CITY OF PROVIDENCE, RHODE ISLAND

RFP Title: Site Improvements at Billy Taylor Park

Addendum #: 2

The purpose of this addendum is to provide updates from pre-bid meeting, revisions to plans, bid package specifications and prevailing wage.

10 SYNLAWN PLAYGROUND SURFACING OVER ASPHALT -ATTACHMENT A
NTS

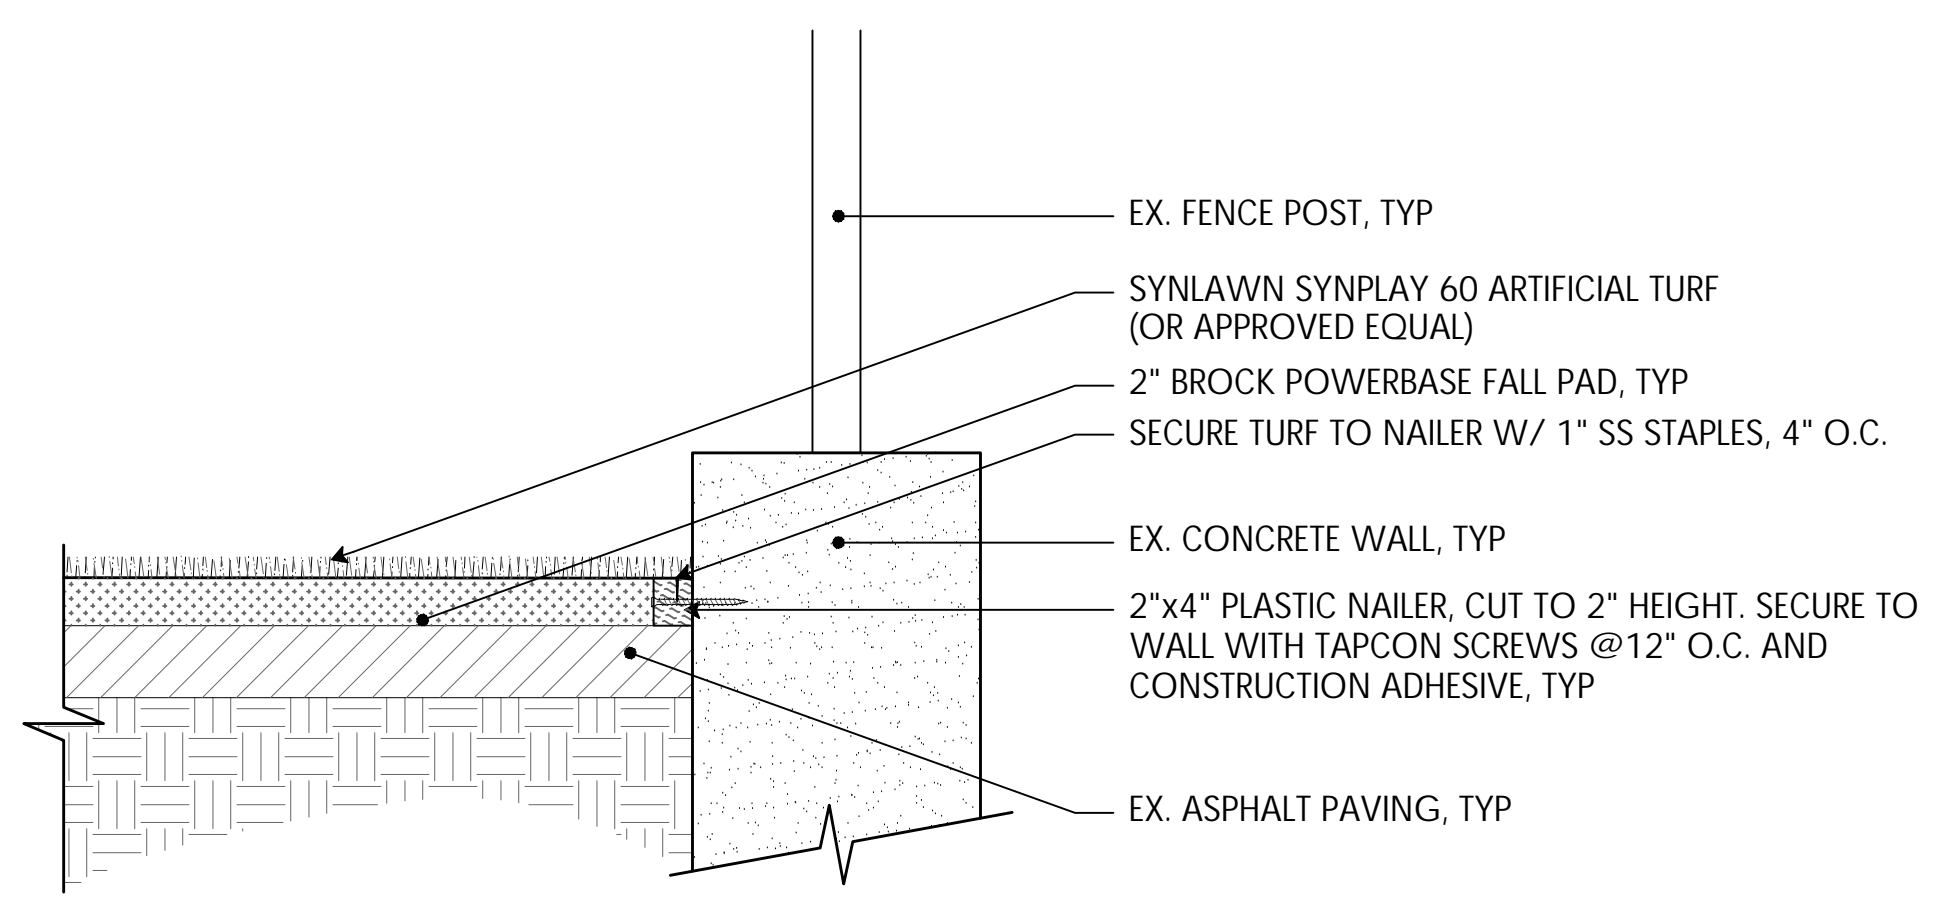
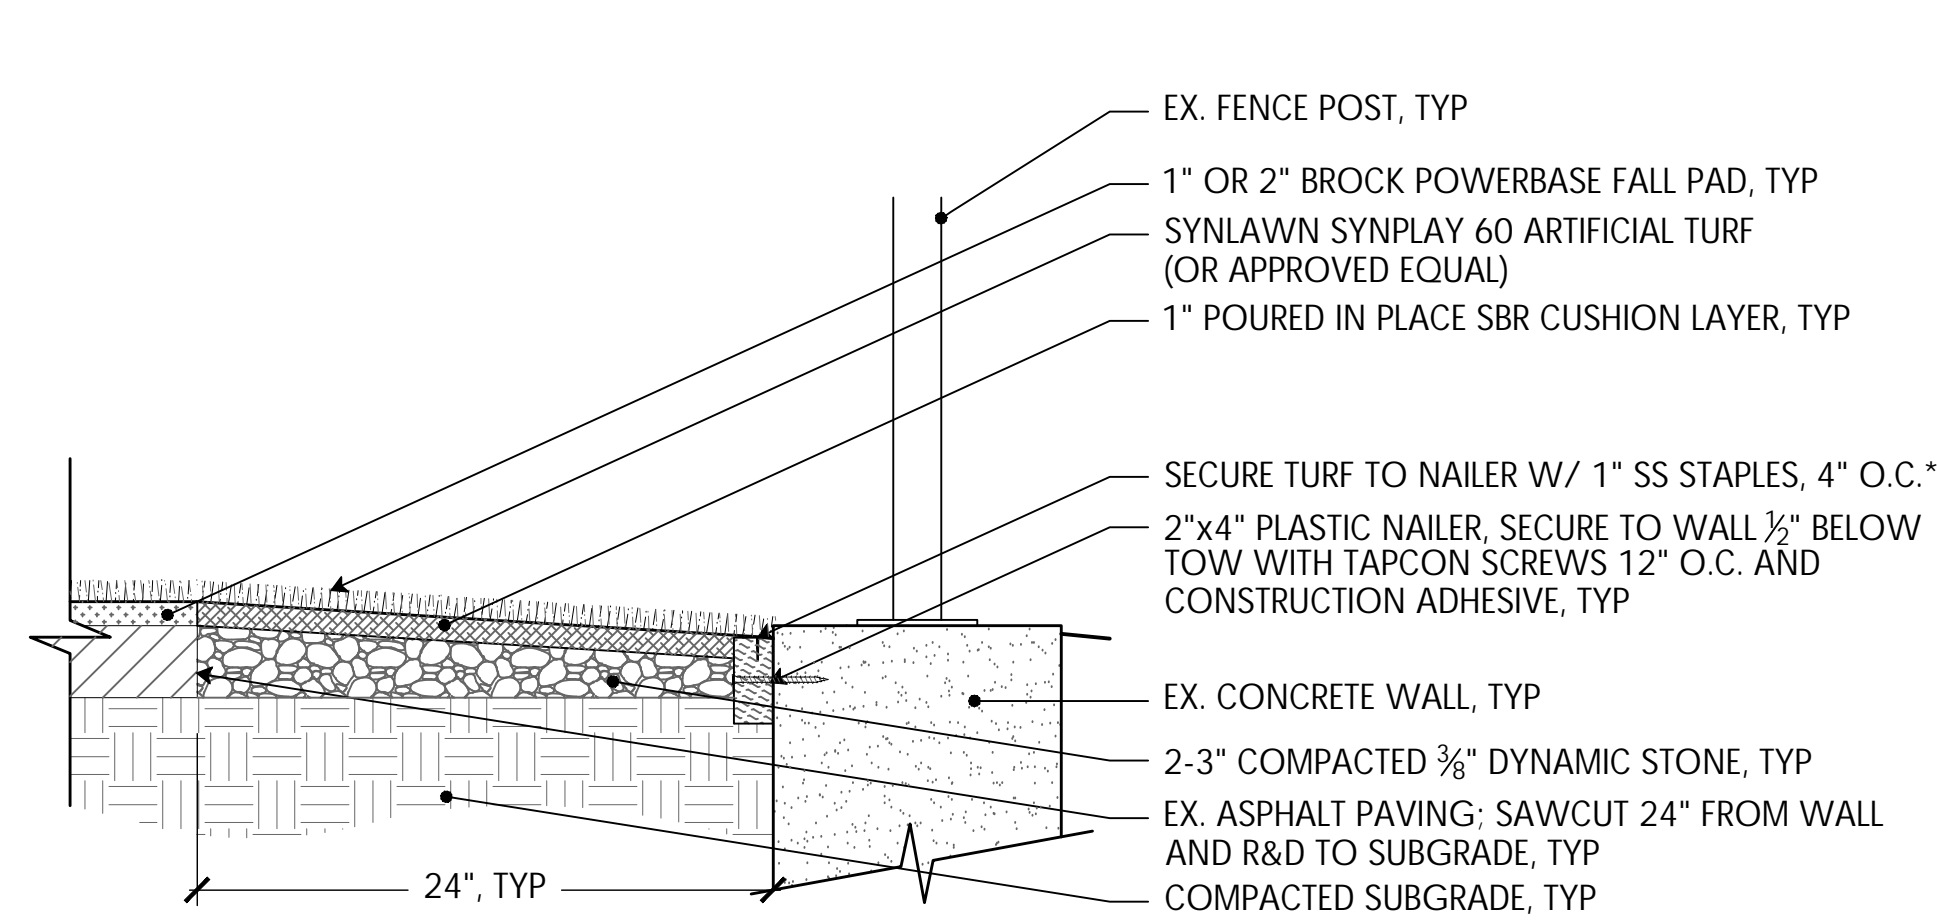
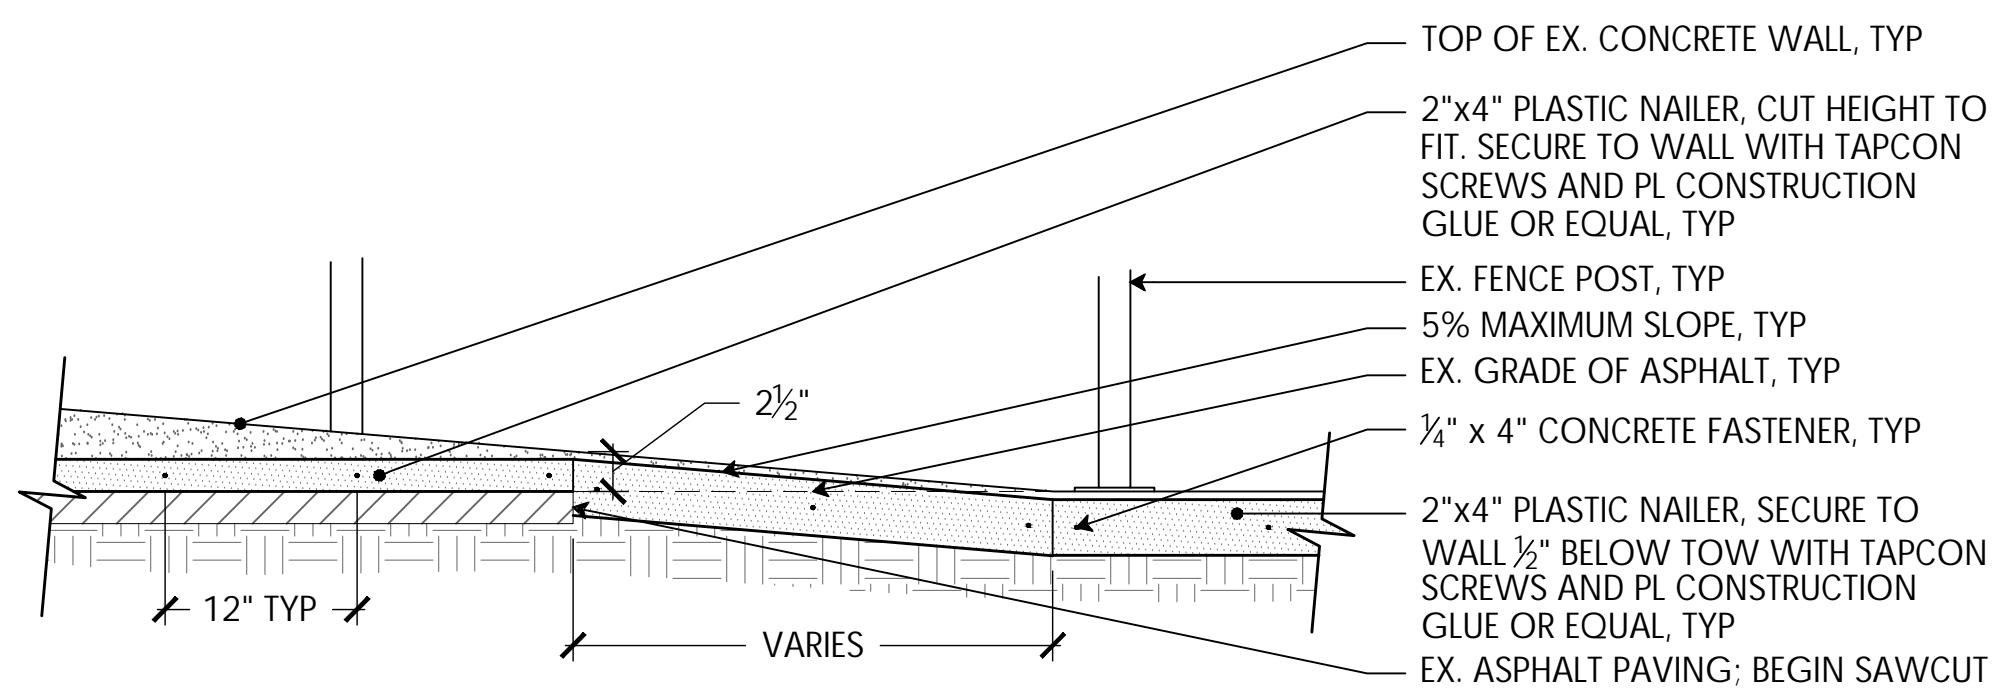
6. Q: Is there a color plan for the synthetic turf?
A: See Addendum plans.

7. Q: Is the playground going to be all new rubber surface?
A: No, it is synthetic turf on existing asphalt base. See plans, details & specs.

Drawing Title
Bonding Layout

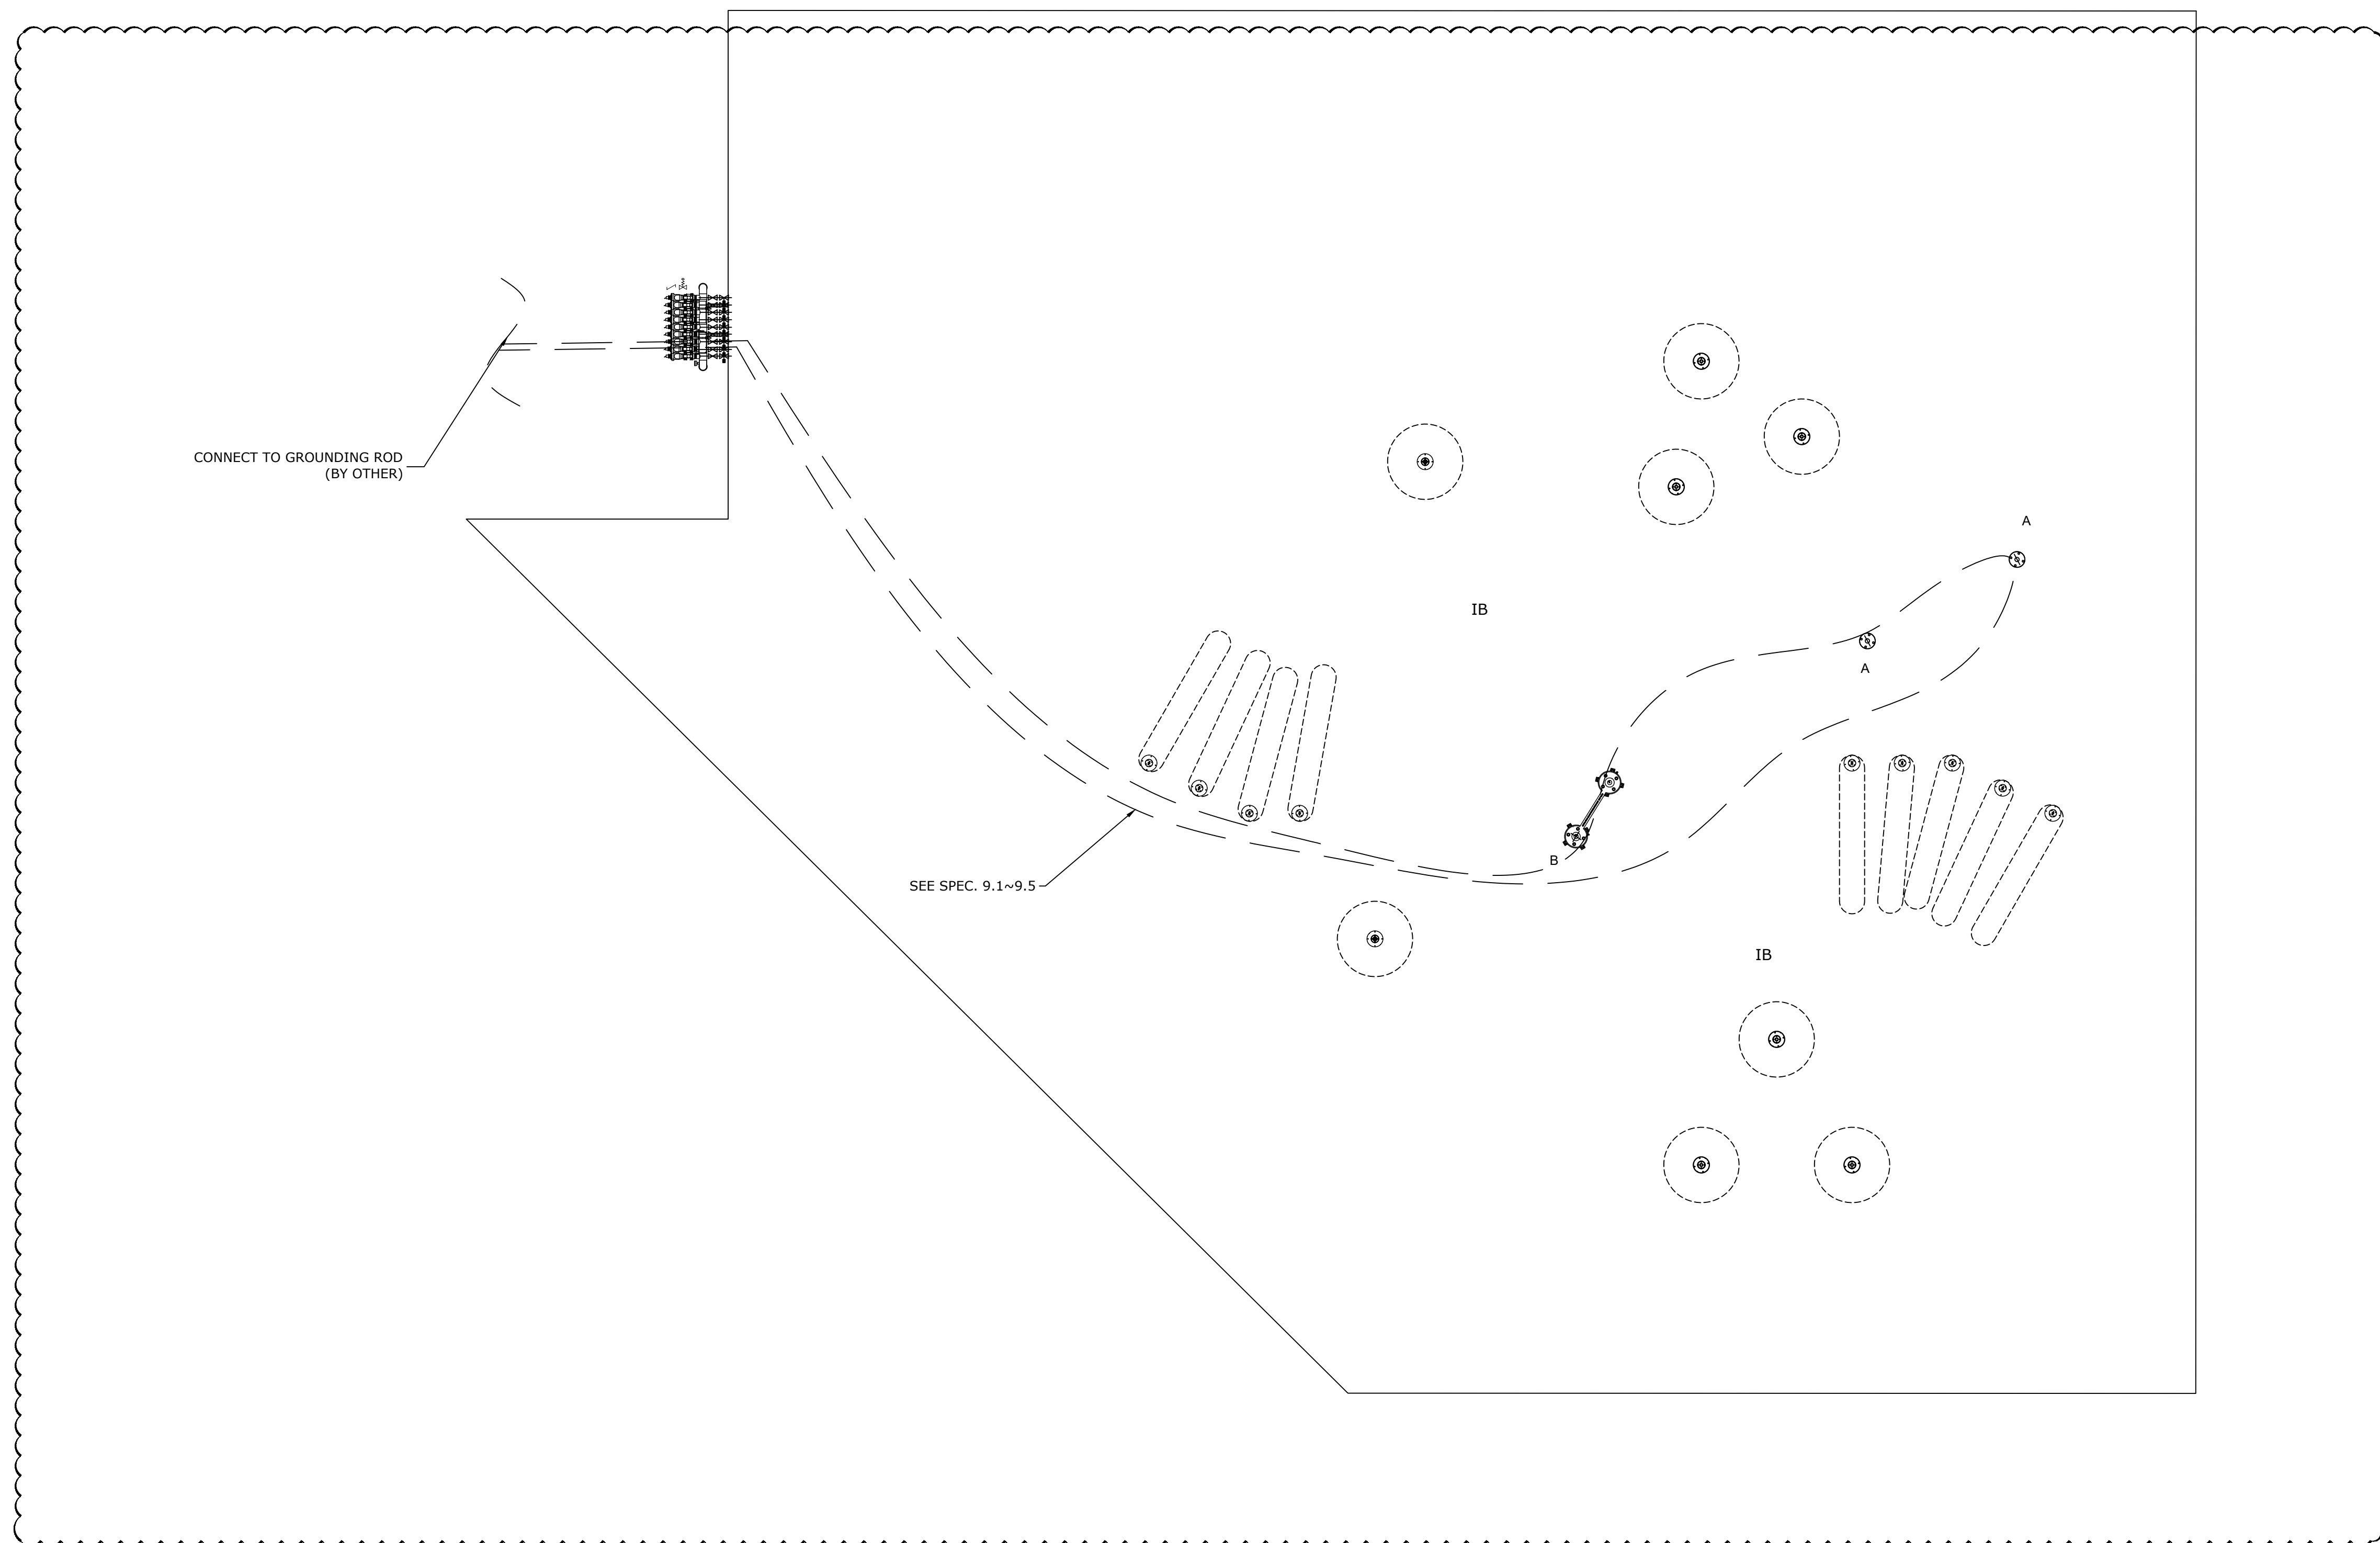
13. Q: Will bonding plan be complete before bid deadline?
A: See addendum plans.
